Applicant: Satoshi Seo et al. Attorney's Docket No.: 12732-0220001 / US7048

Serial No. : 10/801,113 Filed : March 16, 2004

Amendments to the Drawings

Page 6 of 1
Appl. No.: 10/801,113
Amendment in Reply to Office action of November 12, 2008
Annotated Sheet Showing Change(s)

FIG. 6

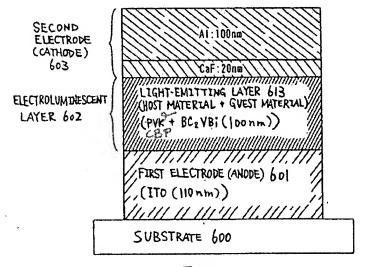
The attached replacement sheet of drawings includes changes to Fig. 6 and replaces the original sheet including Fig. 6.

In Figure 6, "PVK" is replaced with "CBP."

In the paragraph beginning on page 36, line 23, structural formula (15) was incorrectly identified as poly(n-vinyl carbazole) (PVK). The correct name for the molecule shown by structural formula (15) is 4,4'-bis(N-carbazolyl)-1,1'-biphenyl (CBP), as indicated by the product detail page for Product No. 660124 from Sigma-Aldrich (see Attachment 1). This paragraph, which refers to Figure 6, has been amended to correct the chemical name of structural formula (15) from PVK to CBP. This change has also been made in Figure 6, in which the host material incorrectly identified as "PVK" has been amended to correctly identify the host material as "CBP."
